ITEM #: 27a
DATE: 11-15-16

COUNCIL ACTION FORM

REQUEST: MAJOR SITE DEVELOPMENT PLAN FOR 2041 COTTONWOOD ROAD

Attachment A- Landscape Plan

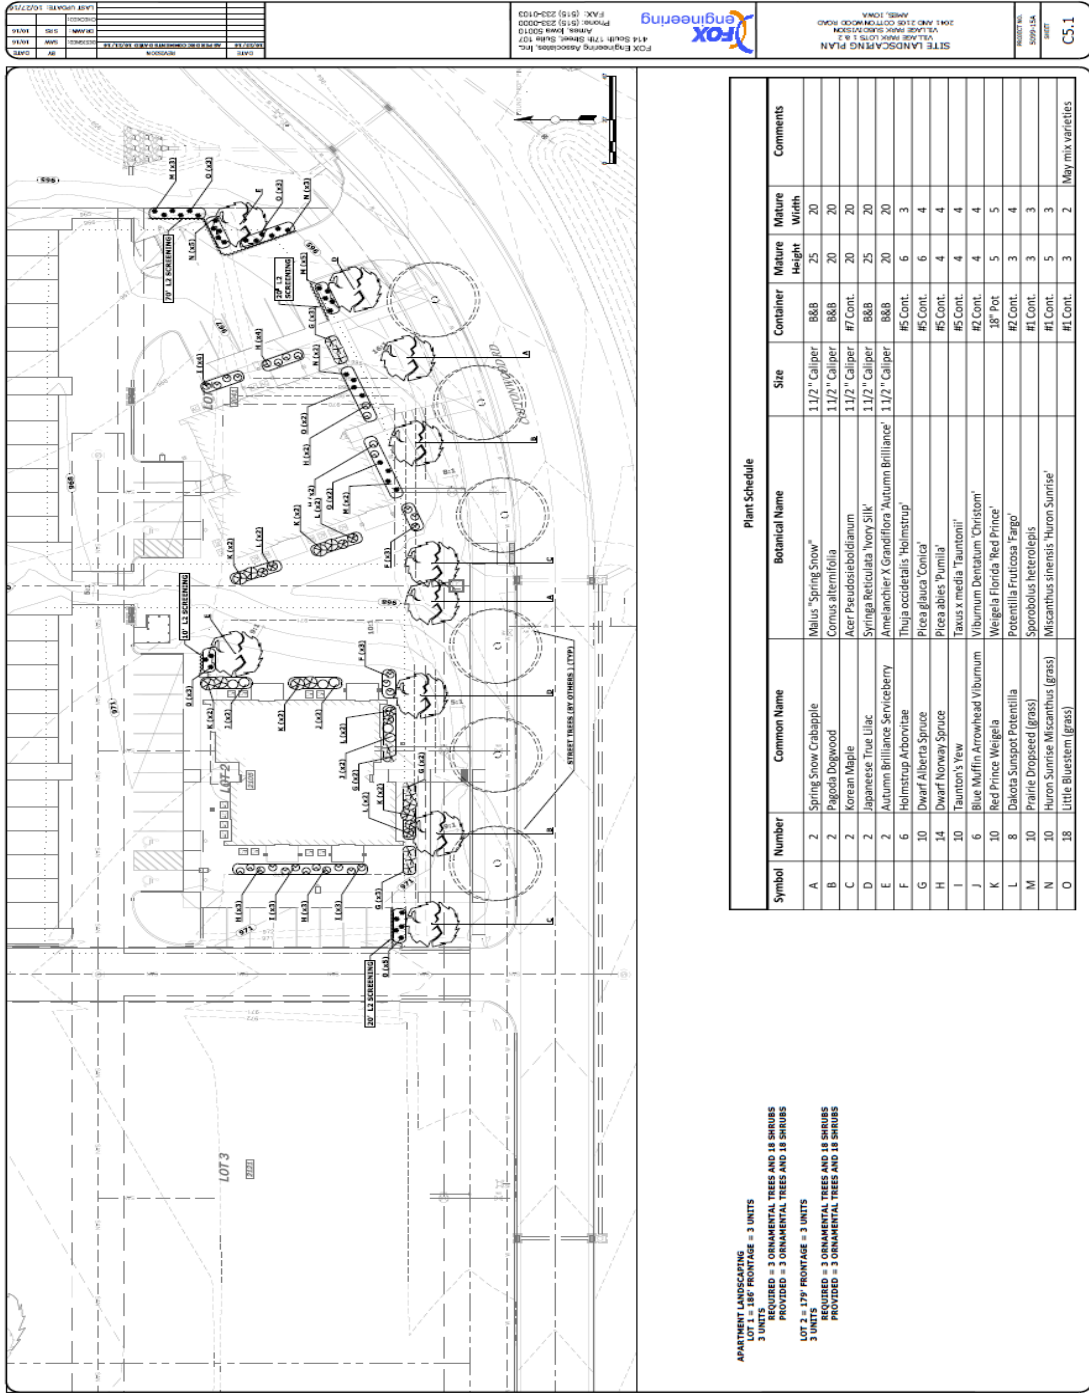
Landscaping is provided to meet front yard apartment foundation and parking lot screening requirements. Due to the one drive aisle configuration of the parking lot no internal plantings are required. The applicant has proposed as alternative parking lot landscaping plan with decorative grasses compared to standard parking perimeter shrubs. Decorative grasses are part of the front yard landscaping as well, but additional foundation landscaping unit plantings with shrubs are still required. No additional landscaping is proposed or required along the rear of the garages. (*See Landscape plan on pg 12*).

Landscape standards require the installation of building foundation screening along the street frontage of an apartment building as well as screening located between the parking area and property lines. As currently configured, the developer seeks approval of alternative parking lot landscaping (29.403(4)(d)) for two issues. The first is to allow substitution of ornamental grasses in lieu of shrubs. The second is to not require screening along the edge parking area on the west side of the site. The developer would be required to plant additional trees and shrubs along the west edge of the site to comply with standard requirements.

The developer believes that the grasses provide a desirable aesthetic to the project and provide for a suitable level of screening. Grasses during the summer months provide effective screening, but in the winter months there is likely no screening as the grasses are cut to allow them to regrow in the spring. In this situation staff believes they are acceptable due to the low sensitivity of other uses abutting the site. The developer believes the 2nd issue of edge landscaping is also unnecessary along the west property line due to the abutting use of parking at the property line. The screening is likely not a substantial issue of compatibility, but an additional tree could be included to meet the intent of the shading over parking areas. This is a similar request that is part of all four proposed project along Cottonwood.

The street frontage foundation landscaping must be a combination of plantings as described in Section 29.403(6)(b). The groupings of foundation plants are referred to as Landscape Units and their quantities specified to meet this requirement. Specifically, there must be trees and 6 deciduous and evergreen shrubs planted for every 60 feet of street frontage. The total frontage at this site is 186 feet. The developer has included appropriate trees, but has not included shrubs as they desired to use grasses. In this instance, the foundation planting must meet the specified planting quantity and substituting grasses is not permitted. A condition is included to revise the landscaping with 8 additional deciduous or evergreen shrubs to be planted along the street frontage side of the building. The proposed grasses can stay in place but shrubs must be added to meet the required plantings for street frontage foundation landscaping.

- C. The landscape plan shall include revisions necessary to specify plantings appropriate in size equal to the height of the mechanical equipment to ensure the compliance with the zoning ordinance screening requirements.

- D. The landscape plan shall be revised to include front yard foundation planting landscaping units compliant with the zoning ordinance standards of Section 29.403(6) of the Municipal Code, this include revisions to the tree configuration of the landscape unit and for eight additional foundation planting shrubs.

Attachment F: Landscape Plan for Outlots A & D, Village Park Subdivision

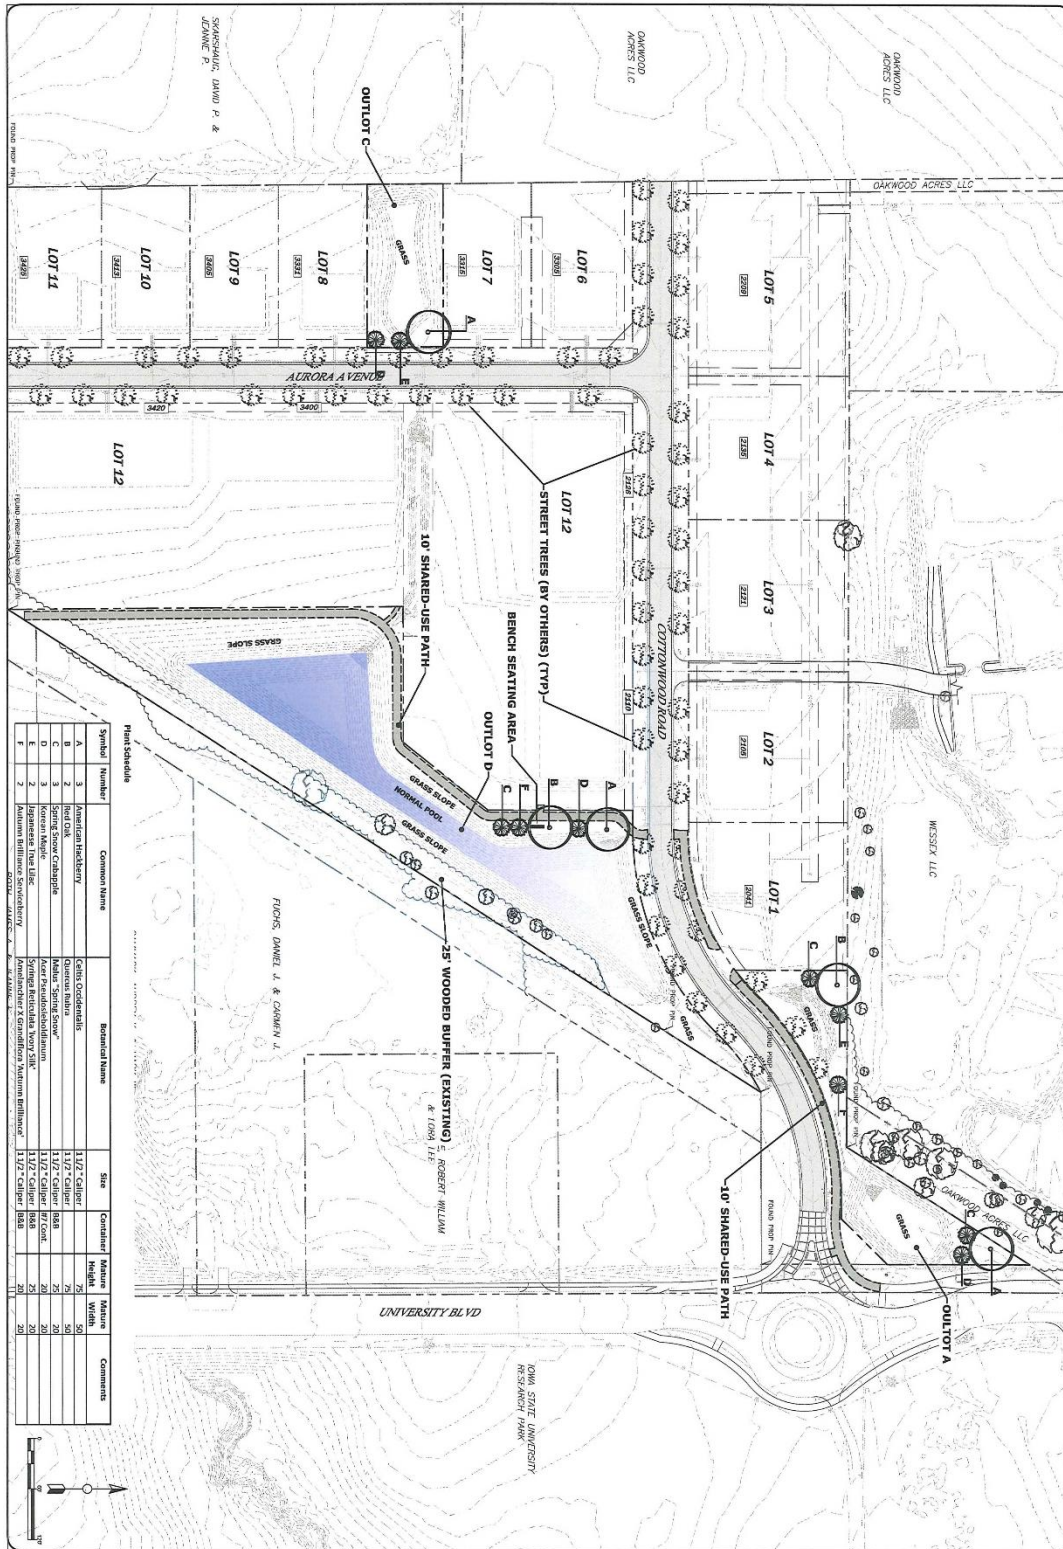
In addition, the required 10% of common open space is accounted for in Outlot A and Outlot D to the immediate east and southeast of the proposed building. FS development standards require 10% open space that meets the intent of accessible and useable by residents. Open space is a subset of the overall landscape area. The Outlot landscaping is approximately 17% of the overall area. The plan for the outlot includes a trail, but is essentially for stormwater management functions. A site plan for Outlot A and D is required to be submitted and approved in conjunction with consideration of this site development plan and is a separate item on the same agenda.

- A. That the landscaping, and site improvements, as shown on the Landscape Plan for Outlots A & D, be installed, prior to occupancy of the first FS-RM apartment building in the Village Park Subdivision;
